Product Change Notification

Change Notification #: 119041-00
Change Title: Intel® Server System R1208WFTZSR, PCN 119041-00, Label, Power Supply (PSU) Label Update
Date of Publication: April 25, 2022

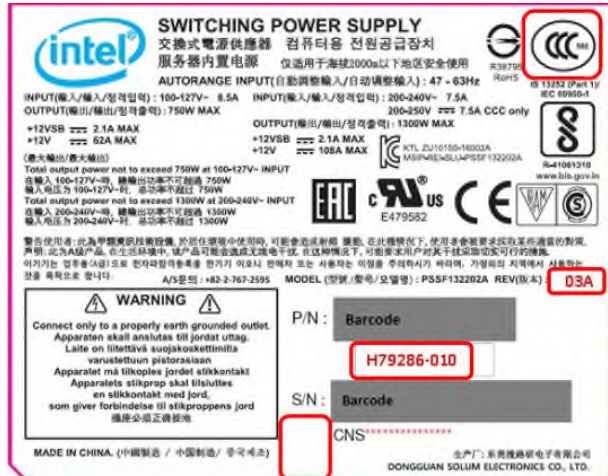
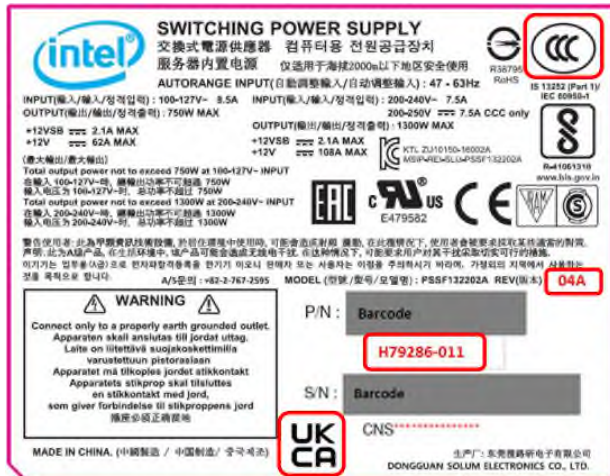
- Adding the UKCA mark and removing S&E from CCC logo on the 1300W Power Supply (PSU) label.
- Power Supply (PSU) is changing from H79286-010 to H79286-011 due to the label modification.
